**OTAY MESA CENTRAL VILLAGE
SPECIFIC PLAN
SAN DIEGO, CALIFORNIA**

PROJECT NO. 07254-42-04

Subject: RESPONSE TO COMMENTS
OTAY MESA CENTRAL VILLAGE SPECIFIC PLAN
SAN DIEGO, CALIFORNIA

Subject: 2nd RESPONSE TO CITY OF SAN DIEGO REVIEW COMMENTS
OTAY MESA CENTRAL VILLAGE SPECIFIC PLAN
SAN DIEGO, CALIFORNIA

LAND USE PLAN

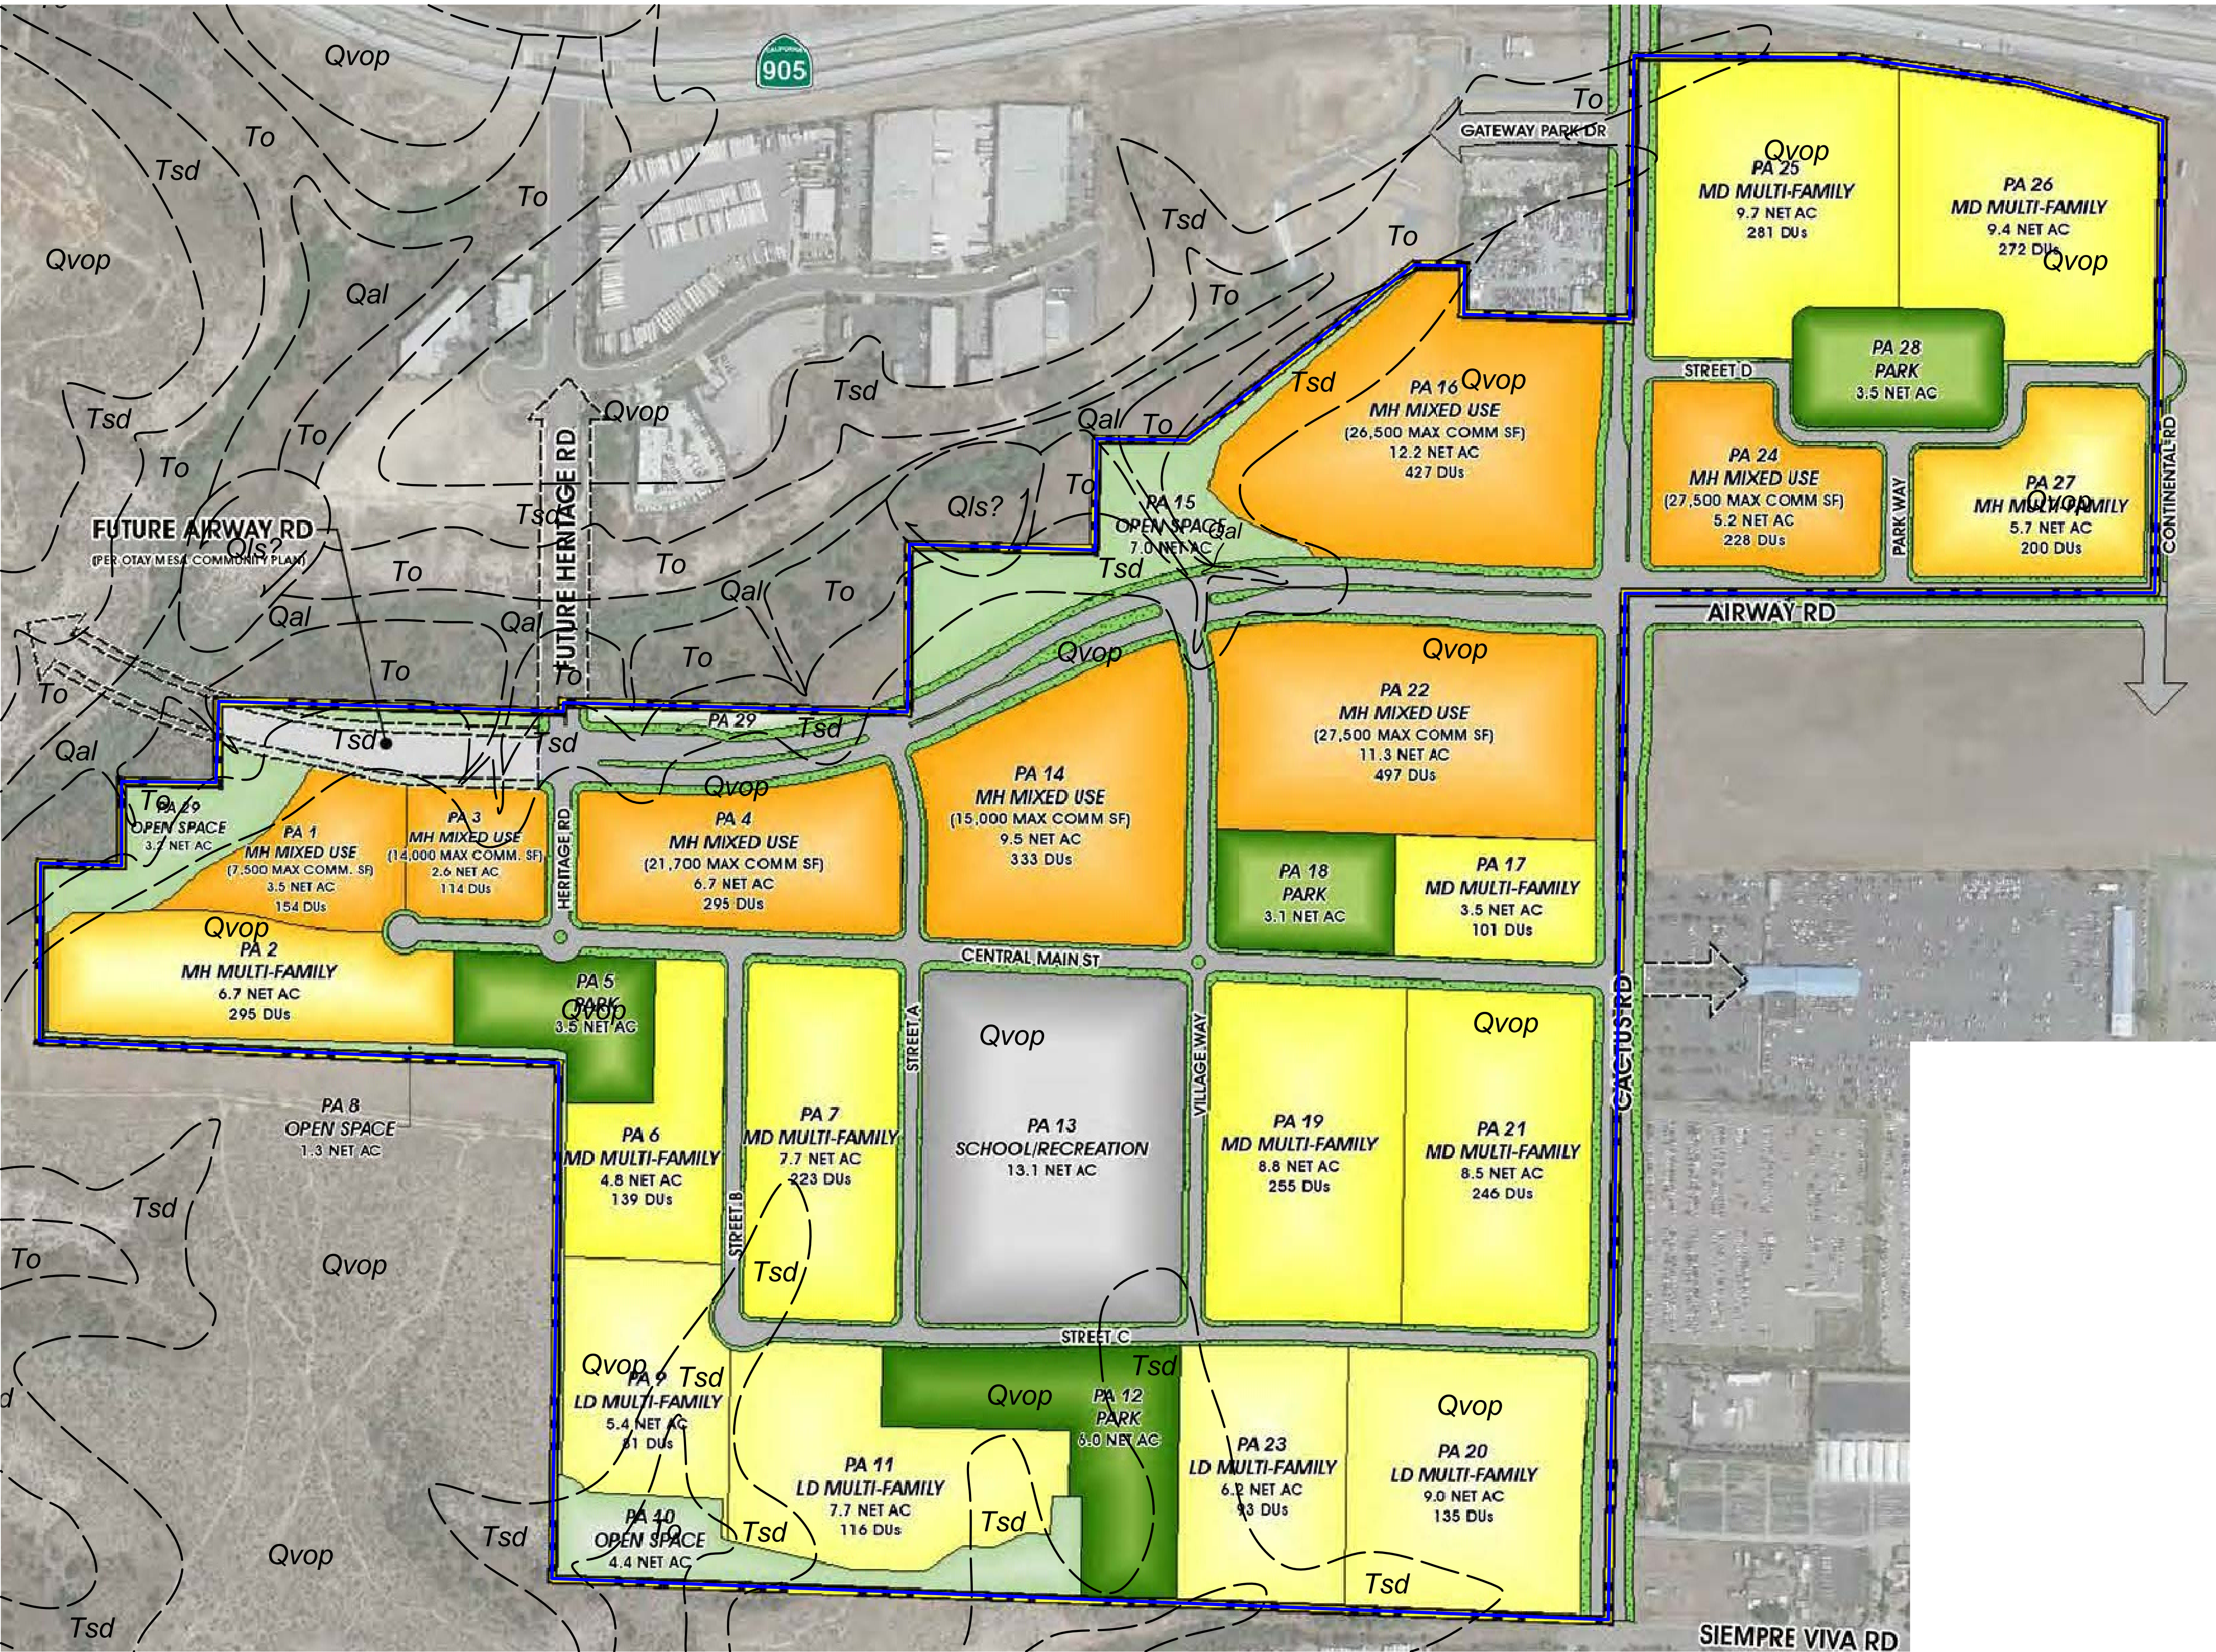
Issue 4: *Provide a geologic/geotechnical map of the Central Village Specific Plan area:*

Issue 5: *Address the potential for slope instability within or adjacent to the plan area, associated impacts, and potential mitigation measures.*

Response: The map is provided herein as Figure 1 (Geologic Map) and Figure 2 (Land Use Plan).

Response: Two landslides are mapped in the vicinity of the Central Village Boundary. Both are located within the canyon drainage area on the north side of the property (see Figure 1). The head of one of the landslides is mapped within the open space area

of PA 15 (see Figure 2). This suspected landslide does not pose a risk to the planned development as it is adjacent to land designated as open space. The risk associated with ground movement hazard due to landsliding is low.

Landslides shown on Figures 1 and 2 are based on published sources or inferred using topography. The shallow, suspected landslides are based on reconnaissance mapping conducted for this report or the City of San Diego Seismic Safety Study (2008) and are not verified by subsurface exploration. As such, the mapped expression of suspected landslides may not be relied upon as definitive of their existence.

GEOLOGIC MAP

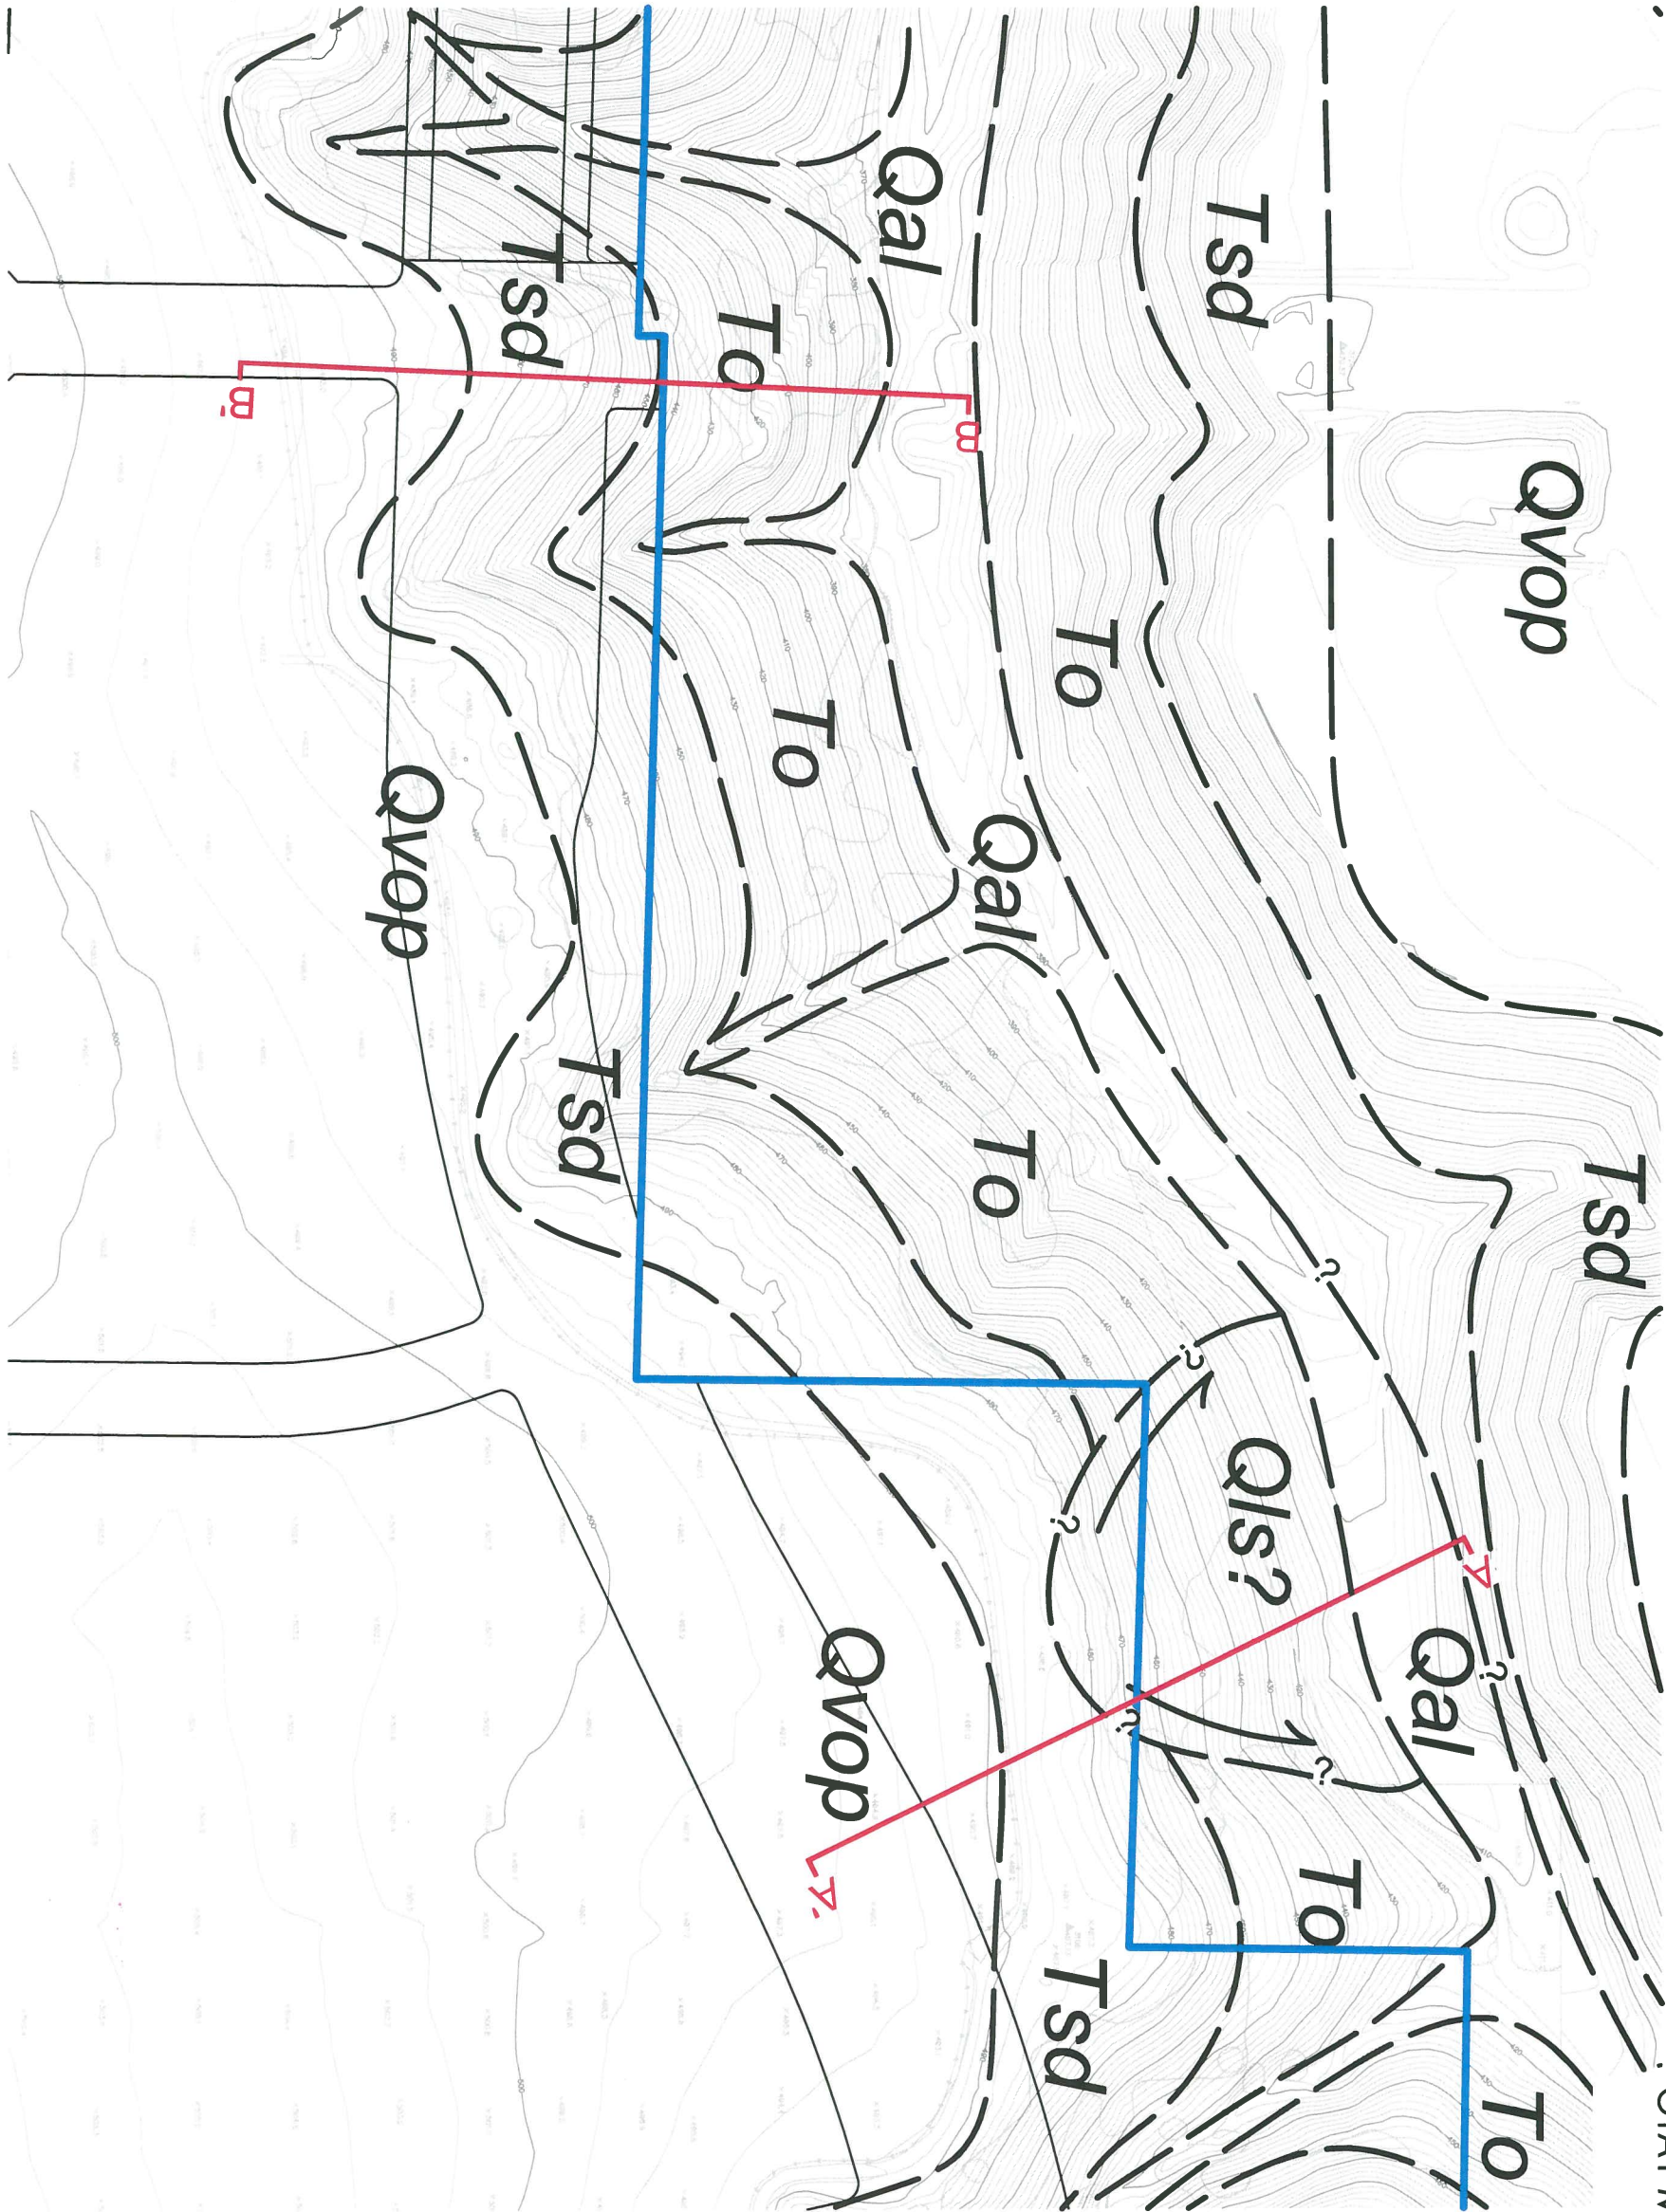
Issue 17: *In their response to comments date October 3, 2016 [Reference 2], the project's geotechnical consultant opines that the risk associated with landslide hazard of the Otay Central Village Specific Plan [Reference 3] is low. However, the geologic map included in their report dated October 9, 2012 [Reference 4] indicates that landslides are suspected along the canyon slope in the northern portion of the of the Specific Plan area. The project's geotechnical consultant should indicate if slope stabilization will be necessary to support the improvements.*

Issue 19: *If stabilization of the slope supporting the planned extension of Airway Road is necessary, identify the approximate limits of grading for the purpose of analyzing the impacts to environmentally sensitive lands.*

Response: We have performed a site reconnaissance and reviewed aerial photographs specific to the proposed alignment of the Airway Road extension, as shown in Reference 3. Based on this review, it is our opinion that there is not convincing evidence to confirm

the presence of the conjectured landslide shown on Figure No. 1. It is also our opinion that, if this conjectured feature is present, its closest horizontal proximity to the proposed roadway is at least 150 feet and the likelihood of the slide impacting the proposed roadway in this area is low. It is our opinion that slope stabilization should not be required to support the proposed roadway improvements.

Response: We don't anticipate that stabilization of the slopes supporting the extension of Airway Road as shown on Reference 3 will be necessary. A slope stability analysis was performed assuming conservative geotechnical conditions along Cross Sections A-A' and B-B' (see Figure 1). The analysis considered the natural slope configuration and assumed the presence of a horizontal Bedding Parallel Shear (BPS) daylighting along the toe of the north-facing slope. Strength parameters for the bedrock and BPS materials were selected based on our experience with the geologic units in the area. The stability analysis was performed using Geoslope 2007. A graphic summary of the stability analysis is provided on Figures 2 and 3. The location of the stability cross sections are shown on Figure 1. Based on our analysis, the minimum factor of safety for the overall existing hillside at the two cross section locations is at least 1.5 or greater. The stability analysis should be confirmed once grading plans have been prepared and a geotechnical investigation has been performed.
